Well Name: TURNER HUGHES

US Well Number: 3004511874

Type of Action: Plug and Abandonment

TURNER HUGHES 16**30.045.11874****PLUG AND ABANDONMENT**

Current Schematic - Version 3

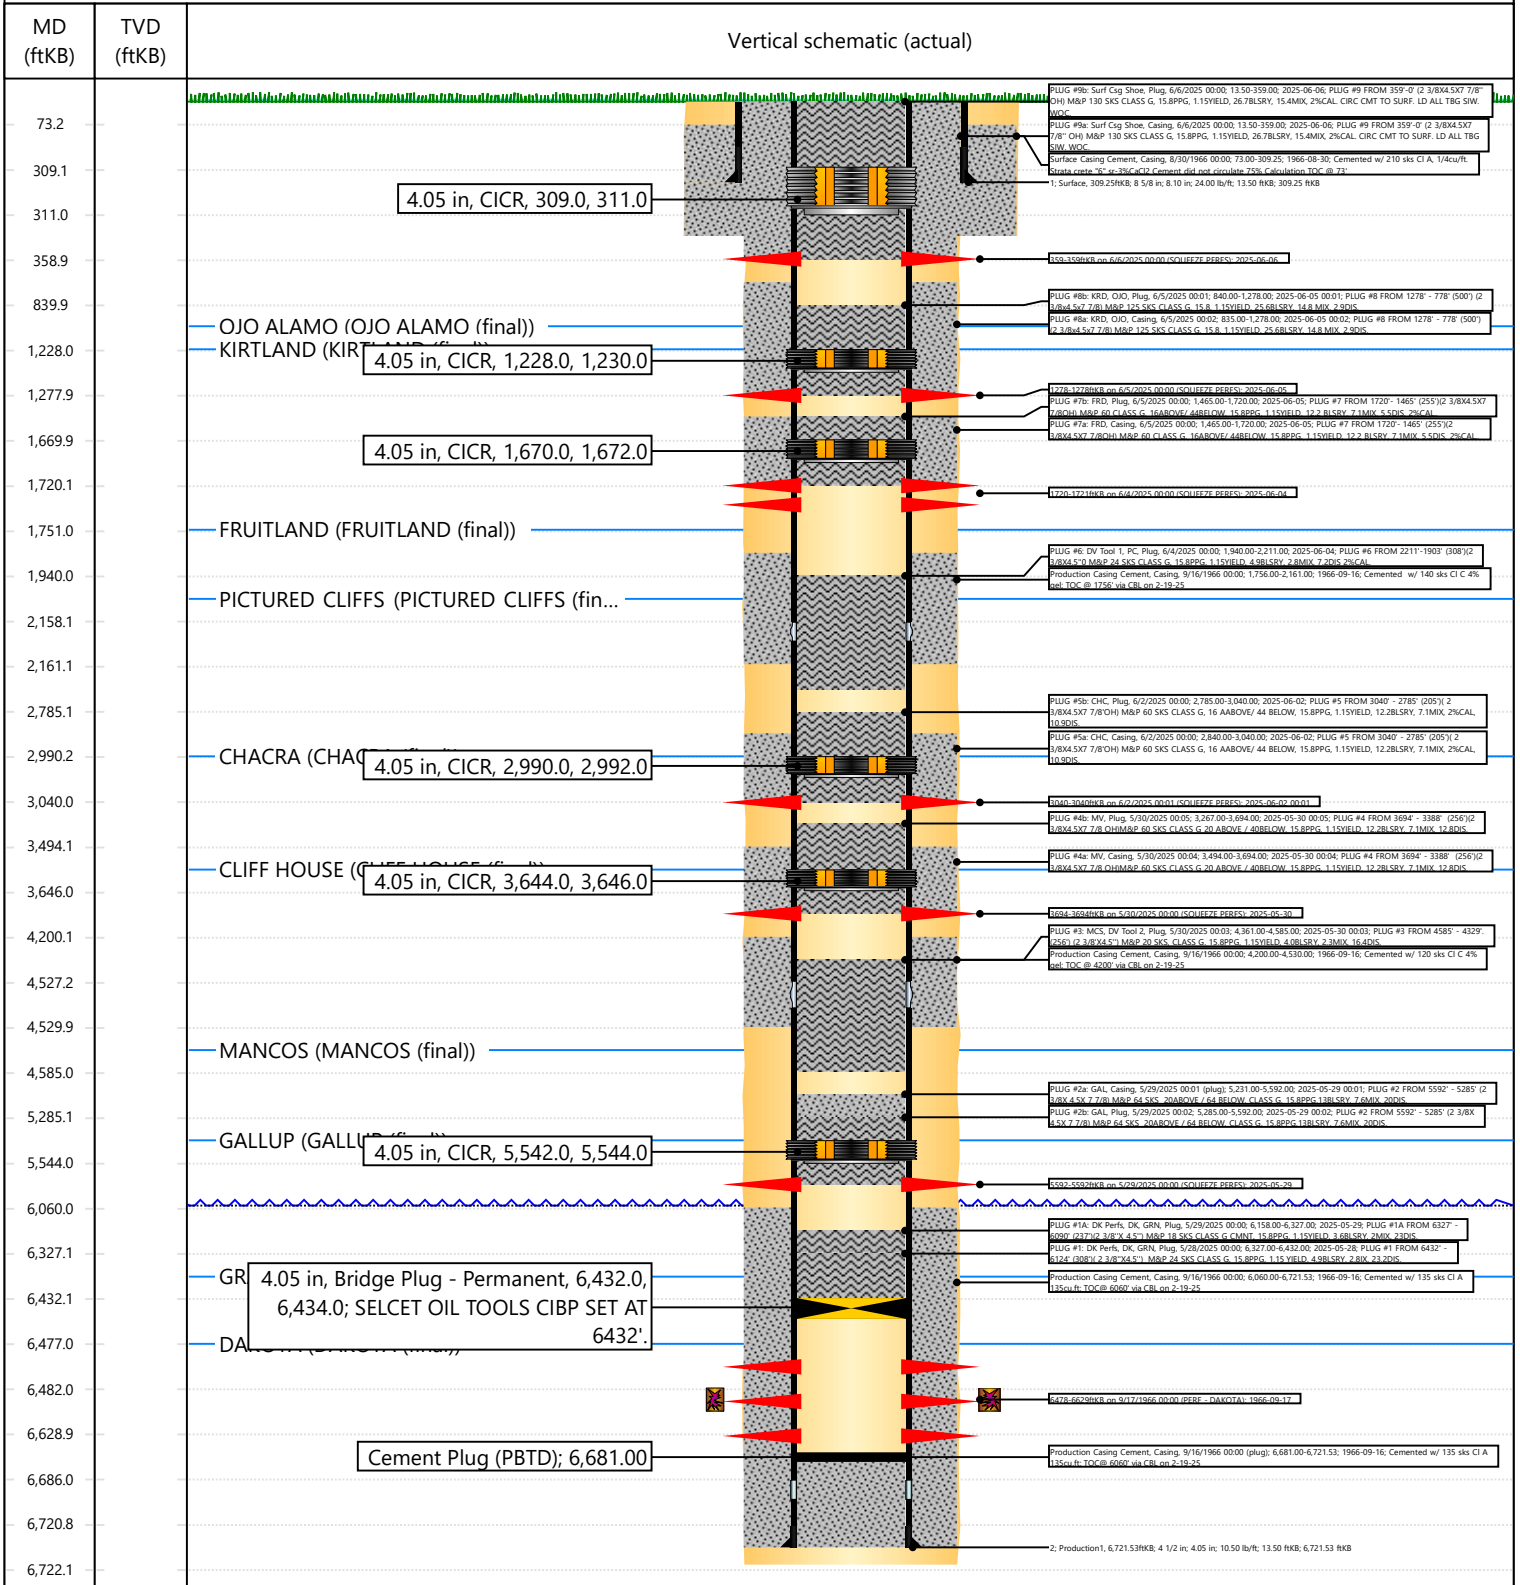
Per our discussion, Hilcorp successfully pumped PLUG #7 as proposed below. Prior to pumping PLUG #7, Hilcorp attempted to pressure test the production casing about the CICR set @ 1,670' w/o success.

- Ahead of pumping PLUG #8 (FRD & OJO): Set a **4-1/2" CICR @ 1,228'**. Perf depth & cement volumes will remain the same as proposed & approved.
- Ahead of pumping PLUG #9 (Surf. Csg. Shoe): Pressure test against PLUG #8. If the pressure test is good, no changes will be made. If the pressure test fails, Hilcorp will set a **4-1/2" CICR @ 309'**. Perf depth & cement volumes will remain the same as proposed & approved.

Per our discussion on the phone, Hilcorp received verbal approval from the NMOCD & BLM to adjust PLUG #7 based on the TOC @ ~1,756' based on the CBL run 2025-02-19:

- **PLUG #7: 52sx of Class G Cement (15.8 PPG, 1.15 yield); FRD Top @ 1,751':**
 - RIH & perf 4-1/2" casing @ **1,720'** (this perf depth is above cement stringers)
 - RIH & set **4-1/2" CICR @ 1,670'** MD.
 - Pump 40sx of cement in the 4-1/2" casing X 7-7/8" open hole annulus (est. **TOC @ +/- 1,520'** & est. **BOC @ +/- 1,720'**). Pump an additional 4sx of cement beneath the 4-1/2" CICR (est. **TOC @ +/- 1,670'** & est. **BOC @ +/- 1,720'**). Sting out of retainer, pump an 8 sack balanced cement plug on top of the CICR. (est. **TOC @ +/- 1,570'** & est. **BOC @ +/- 1,670'**).
 - WOC for 4 hrs, tag TOC w/ work string. *Note cement plug lengths and volumes account for excess.
- The remainder of the P&A procedure will be executed as previously approved.

Per our discussion, Hilcorp TIH to 6,432' (tagged the CIBP at that depth), and pumped PLUG #1. After WOC, Hilcorp RIH & tagged low @ 6,327' MD.

- **PLUG #1a: 18sx of Class G Cement (15.8 PPG, 1.15 yield); DK Perfs @ 6,478' | DK Top @ 6,477' | GRN Top @ 6,313':**
 - TIH w/ work string & tag TOC @ 6,327' MD.
 - Pump an 18 sack balanced cement plug inside the 4-1/2" casing (est. **TOC @ +/- 6,100'** & est. **BOC @ +/- 6,327'**).
 - WOC & Tag
- The remainder of the P&A procedure will be executed as previously approved.

To confirm, the BLM finds the procedure appropriate.

To confirm, the BLM finds the procedure appropriate.

To confirm, the BLM finds the proposed procedure appropriate.
